ADDENDUM NO. 1

EAST PATROL OPERATIONS DIVISION NORTH RENOVATIONS RE-BID
(10% MBE PARTICIPATION GOAL)

January 29, 2026

SHEET NO.
E2.0

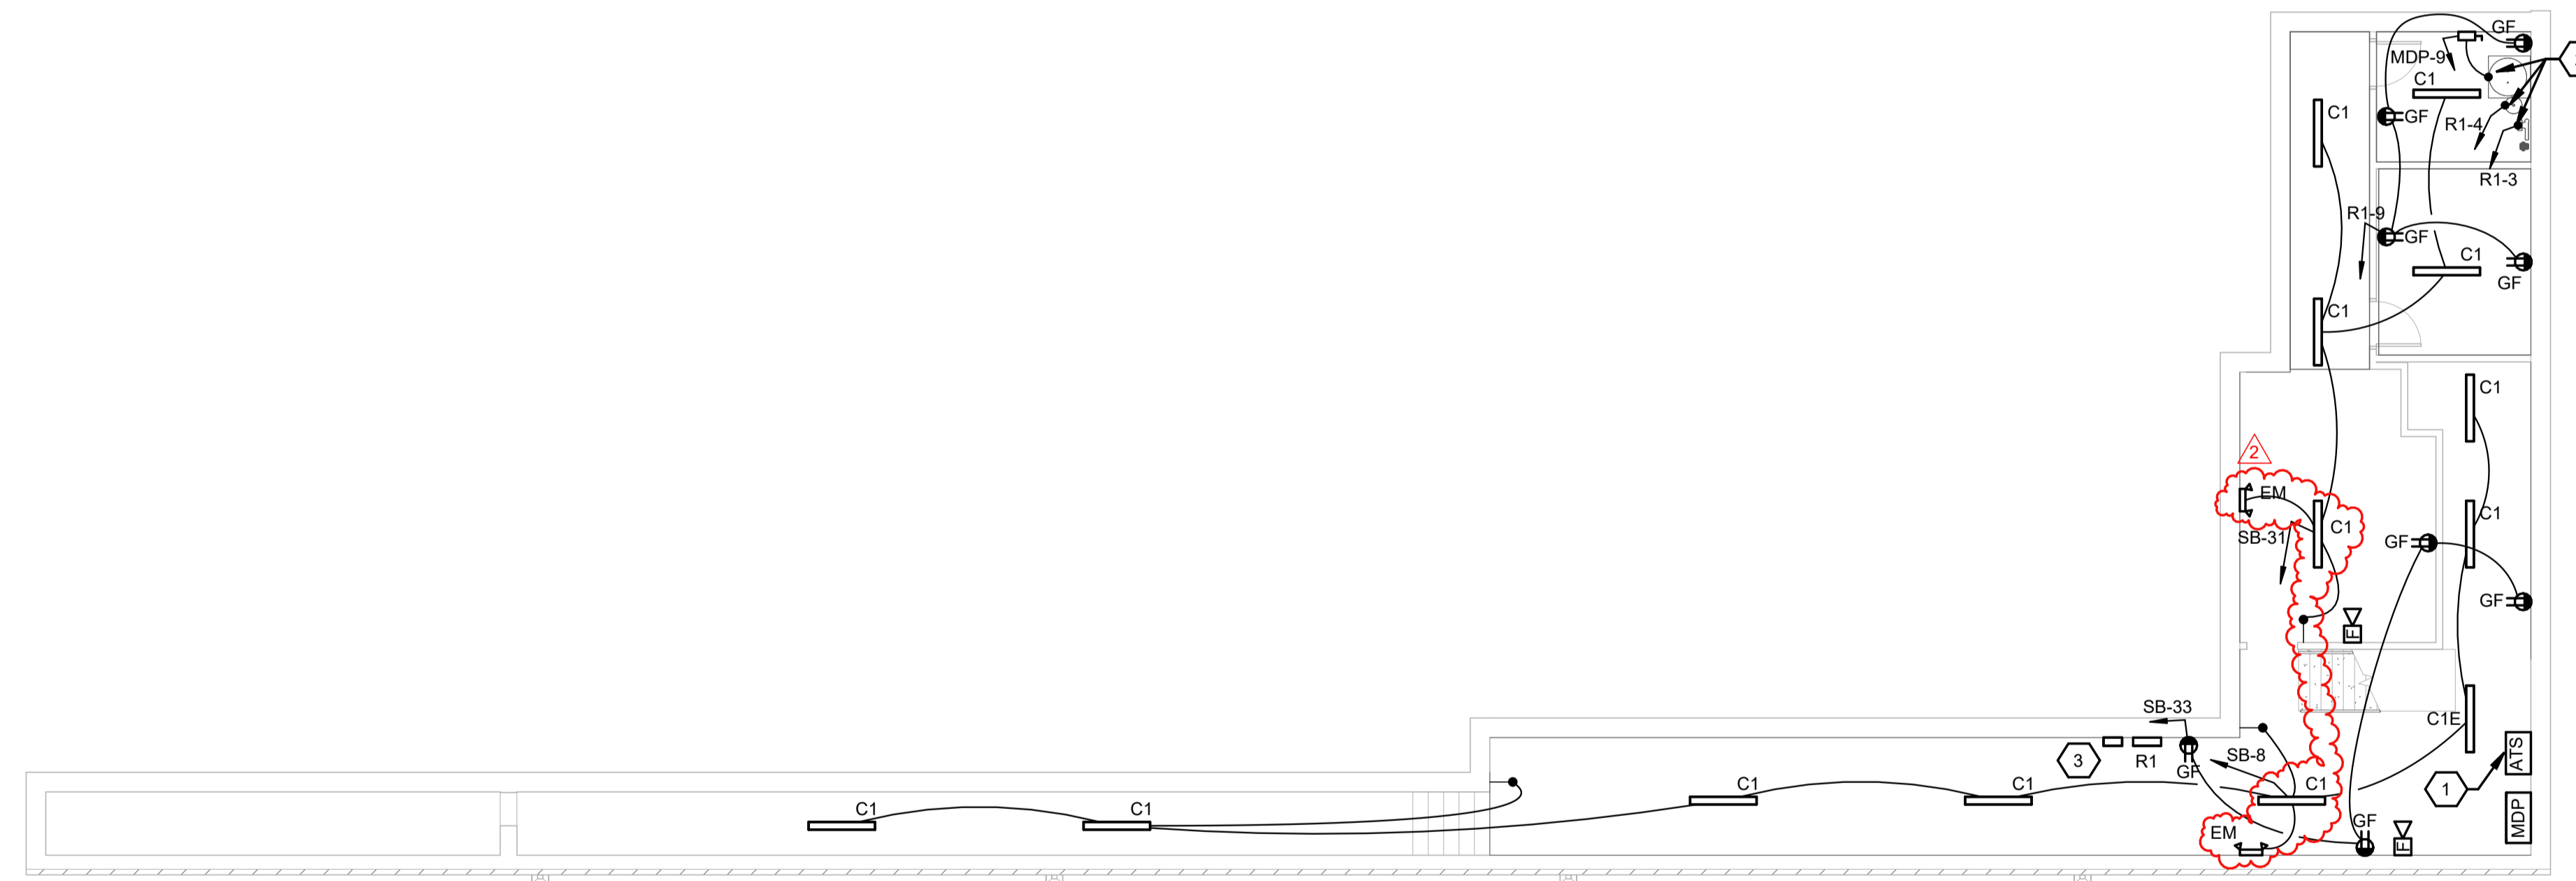
Sheet E2.0: Revised EM lighting

SHEET NO.
E2.1

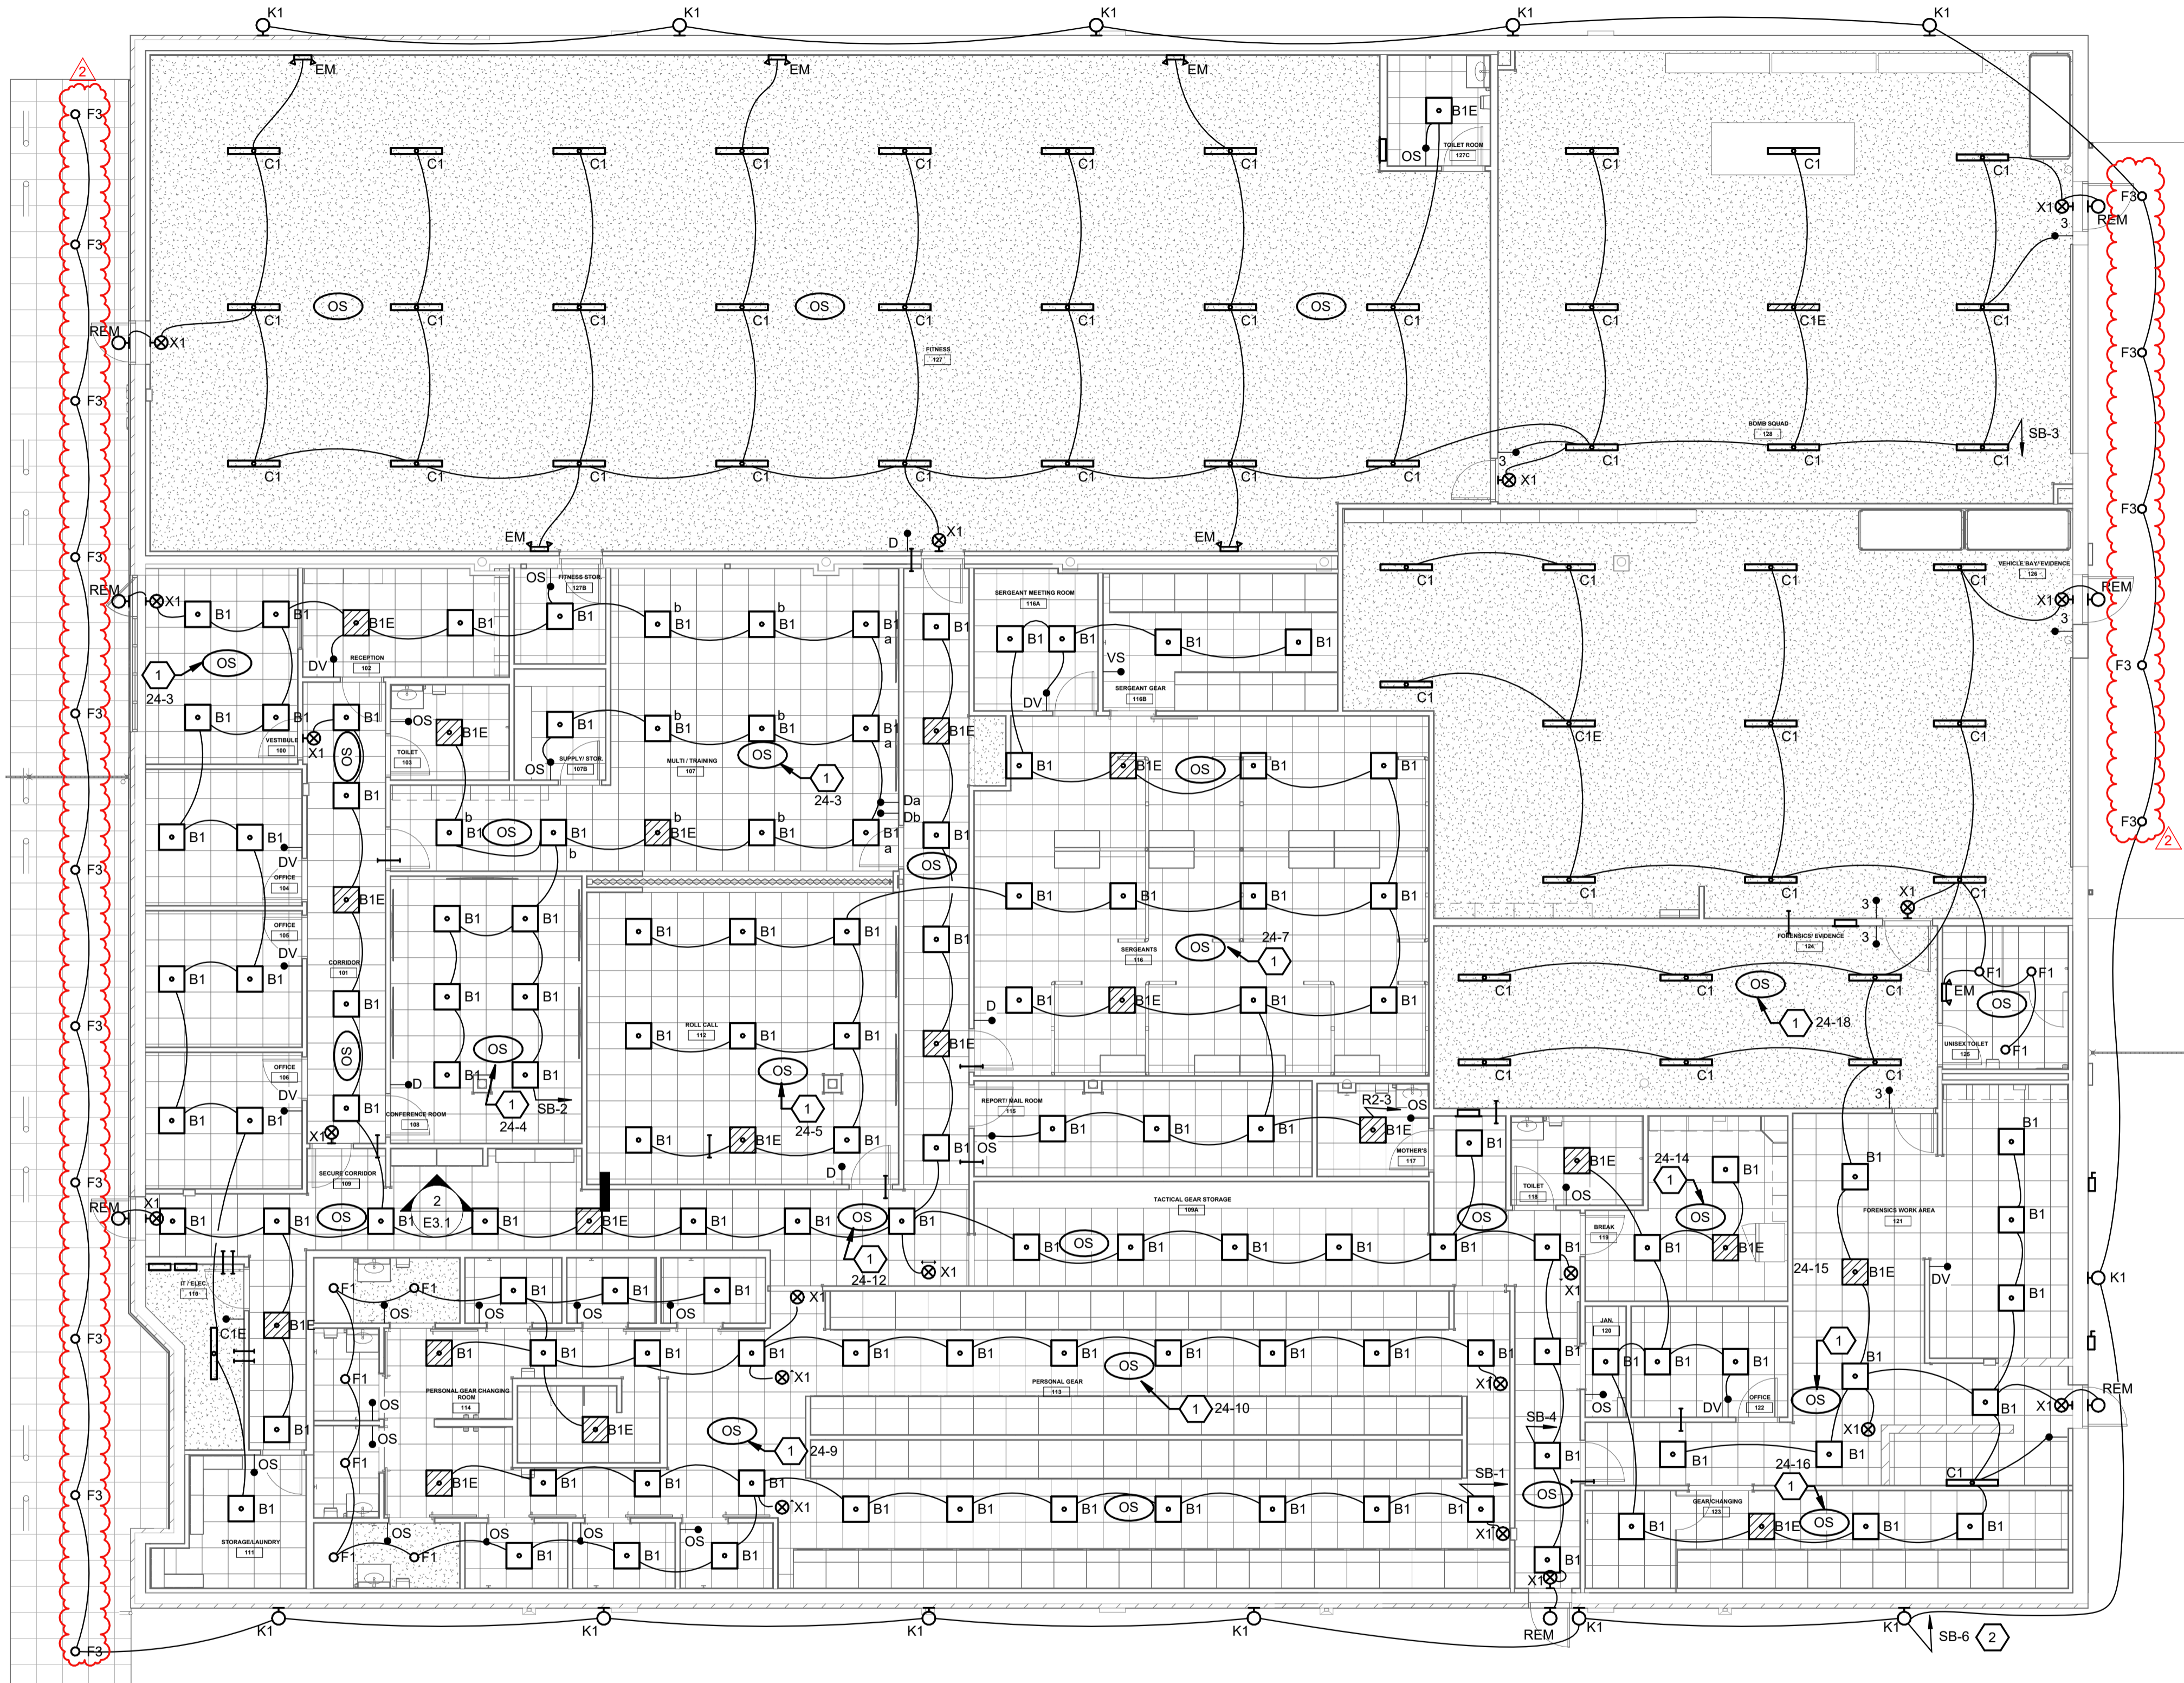
Sheet E2.1: Revised exterior canopy lighting

FIRST FLOOR POWER PLAN
SCALE: 1/8" = 1'-0"

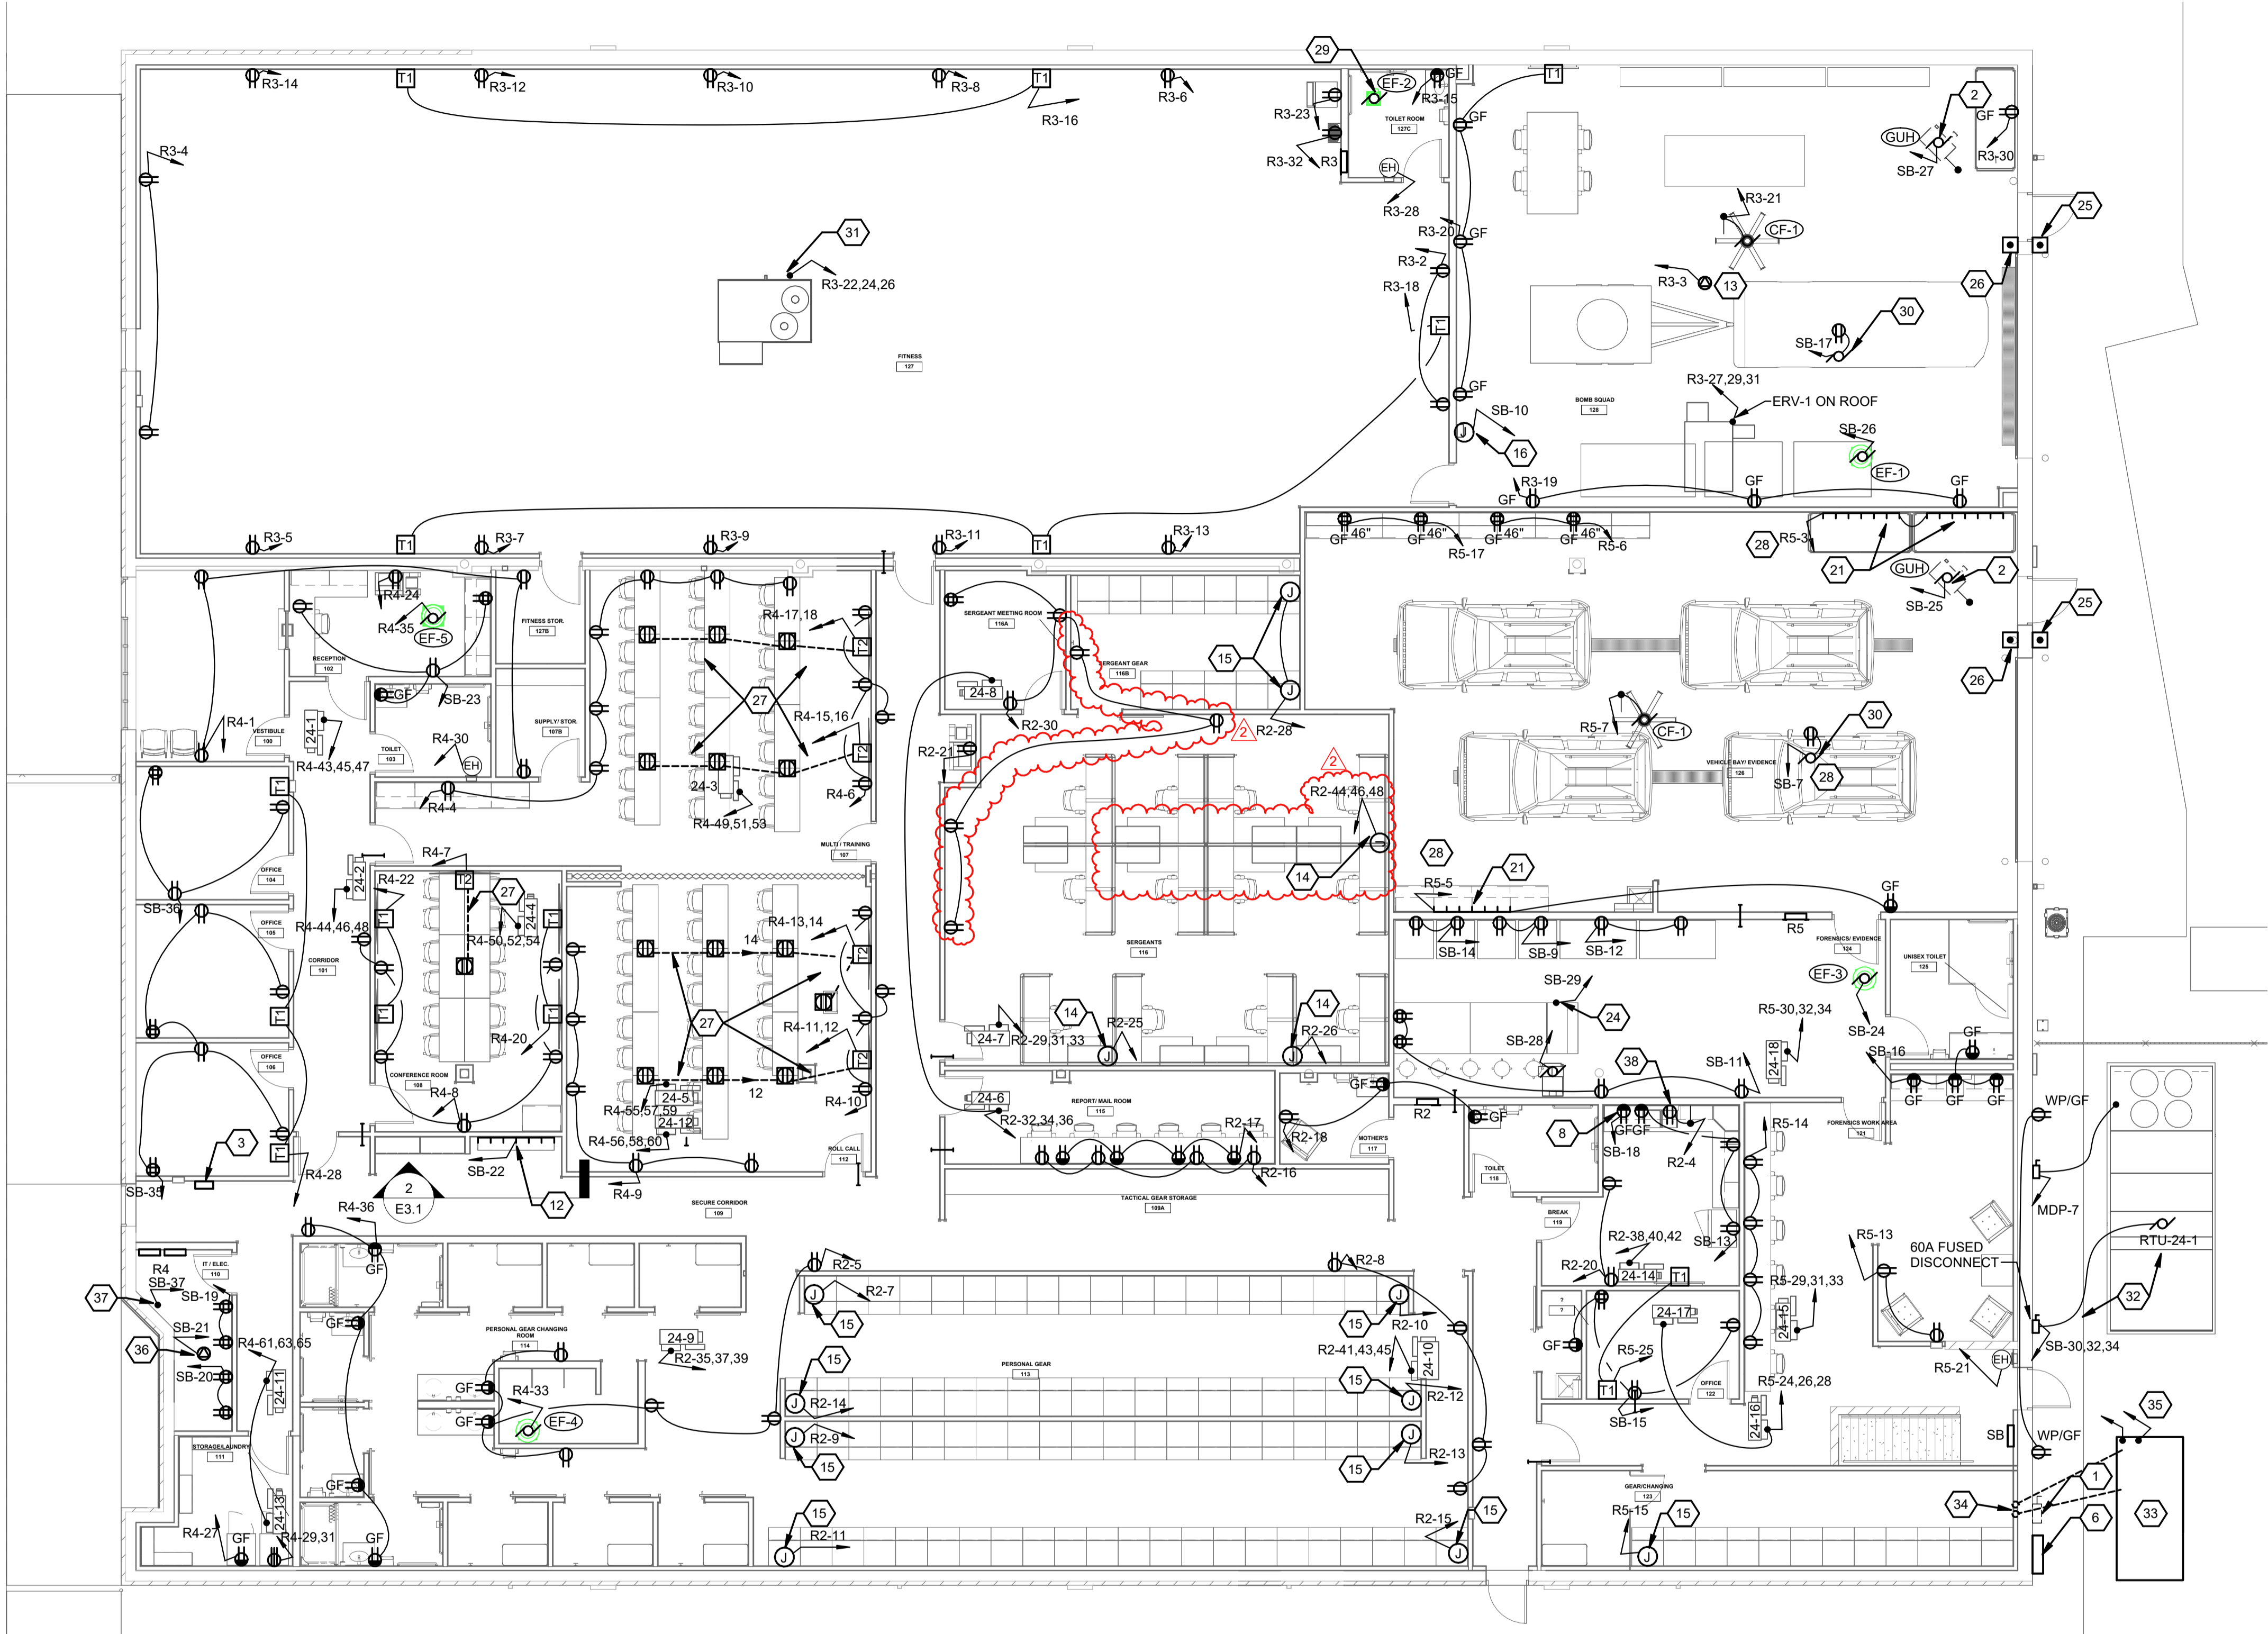
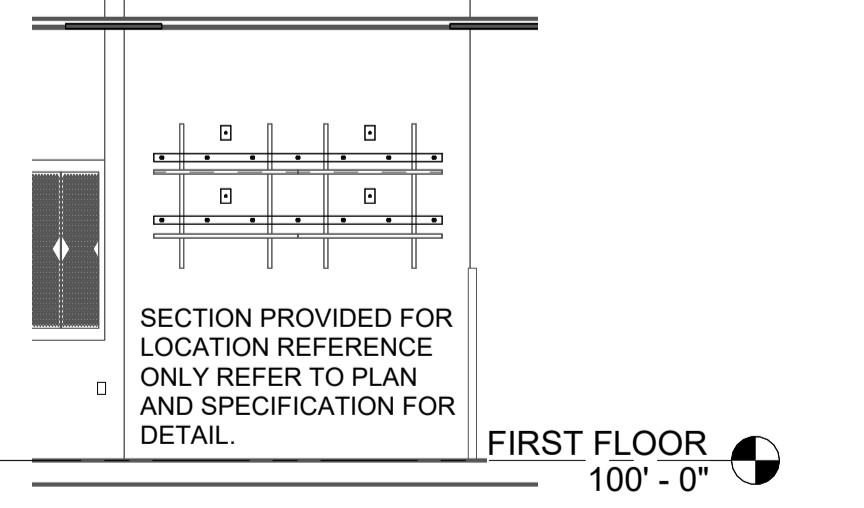
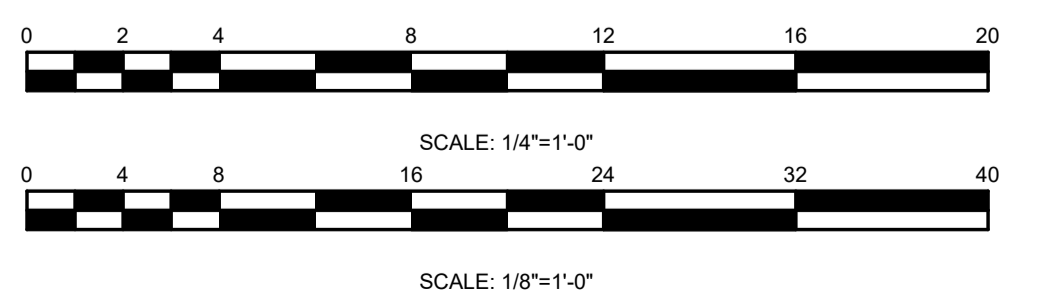
Sheet E3.1: Revised receptacle circuitry
